# Access Compliance Report

## Public Rights-of-Way

### (Curb Ramps)

Intersection ID: 44417	Main Street: MARVIN_RD	Cross Street: ARDREY_KELL_RD	Location:	N
ADA ID: 86BBF6501AC9	Ramp Type: Perp	Initial Pass/Fail: Pass	Overall Compliance: No	Severity Score: 0.25

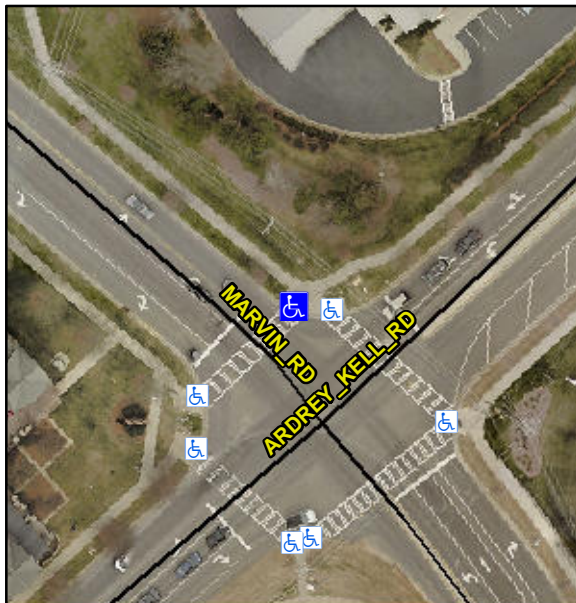
**Not Found, R304.5.3, R305.2**

Compliance	Description	Data	Compliance	Description	Data
N/A	Ramp Length (in)	120.0	Yes	Ramp Slope (%)	6.6
Yes	Ramp Width (in)	49.0	No	Ramp XSlope (%)	3.6
N/A	Flare Type LT	Sloped	N/A	Flare Type RT	N/A
N/A	Flare Slope LT (%)	6.5	Yes	Flare Slope RT (%)	3.0
N/A	Flare Traversable LT?	Yes	N/A	Flare Traversable RT?	Yes
Yes	Landing Length (in)	72.0	Yes	DWS Provided?	Yes
Yes	Landing Width (in)	49.0	Yes	DWS Contrast?	Yes
Yes	Landing Slope (%)	1.4	Yes	DWS Length (in)	24.5
Yes	Landing X Slope (%)	1.7	Yes	DWS Full Width?	Yes
N/A	Landing Curb? (Y/N)	No	No	DWS Offset (in)	5.0
N/A	Shared Landing?	No			
Yes	Gutter Ponding?	No	Yes	Gutter Slope (%)	1.8
Yes	Gutter Lip Ht (in)	0.0	Yes	Gutter X Slope (%)	1.9
N/A	Painted X Walk1?	Yes	N/A	Painted X Walk2?	N/A
	X Walk 1 Direction	To SW		X Walk 2 Direction	N/A
N/A	X Walk 1 Width (in)	113.0	N/A	X Walk 2 Width (in)	N/A
	X Walk 1 Slope (%)	0.8		X Walk 2 Slope (%)	N/A
	X Walk 1 X Slope (%)	0.7		X Walk 2 X Slope (%)	N/A

**Remove & Replace Entire Ramp.**
